Fw: Automated Word Report -QAQC Comments

From: Urvi Pawar <upawar@CANNONDESIGN.COM>
Sent: Tuesday, 16 June 2026 15:59:15
To: Khelan Mehta <KMehta@CANNONDESIGN.COM>
Subject: Automated Word Report -QAQC Comments

Figure 1: Energy Model

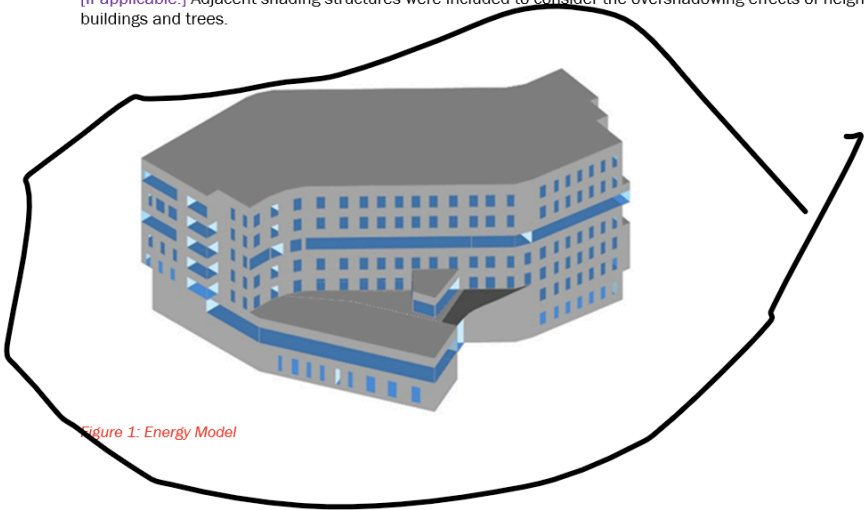
Can you have a section in the parser where the energy modeler - inserts a snip of his model. - Test this out with Casa. Take a snip of the model positioning the same way we did the daylight n

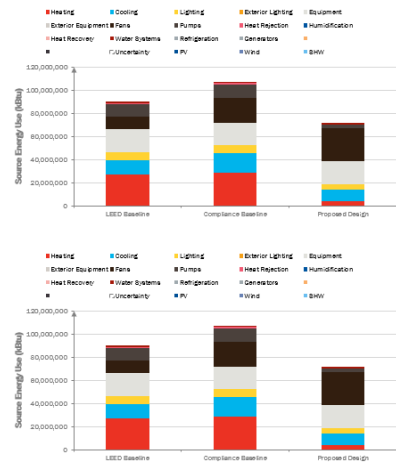
These graphs are not on the right page.

First thing is that the graphs should be on a second page after the page – see example below. Also each graph should have a title **Figure – “ Graph title”**

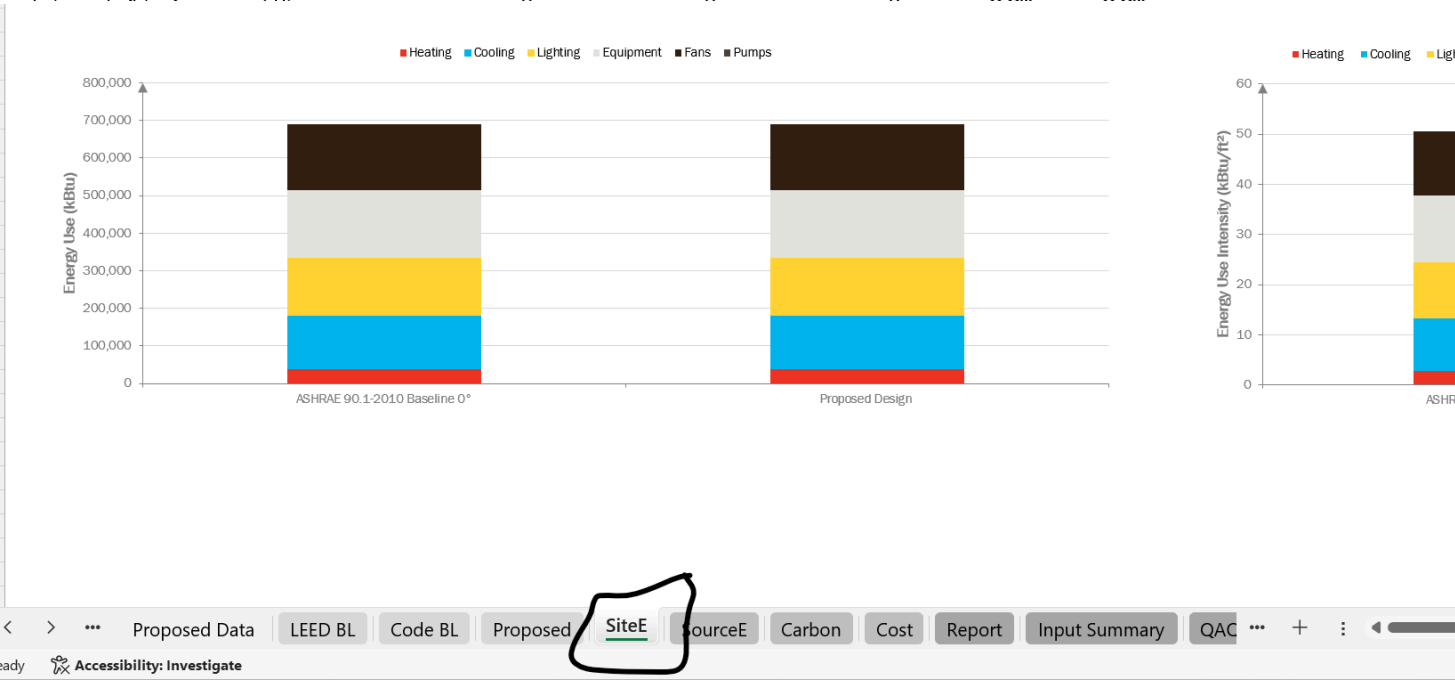
The tables and corresponding graphs are as follows

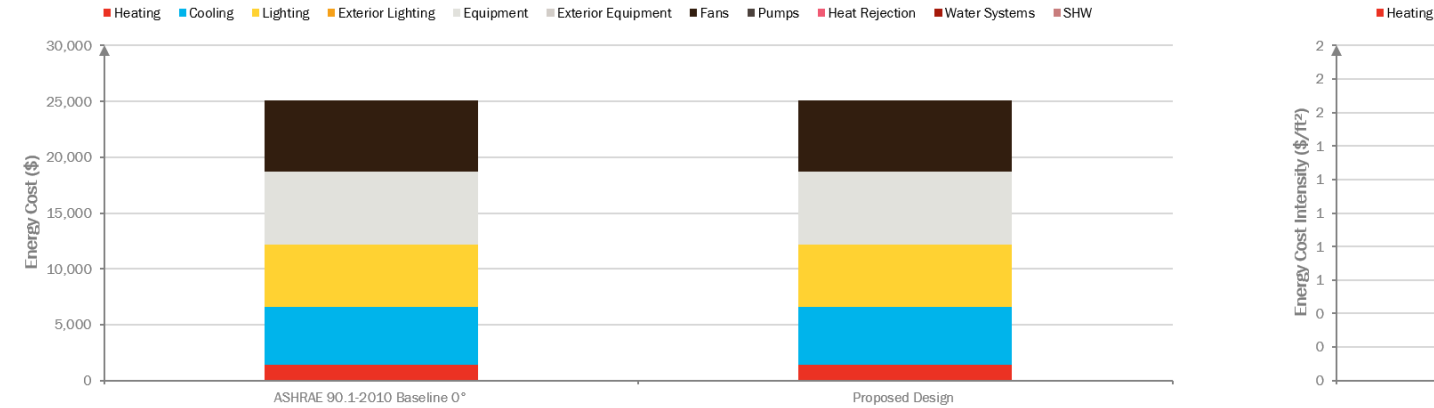
Also in the tables.

When there is no code model – we should not have this column
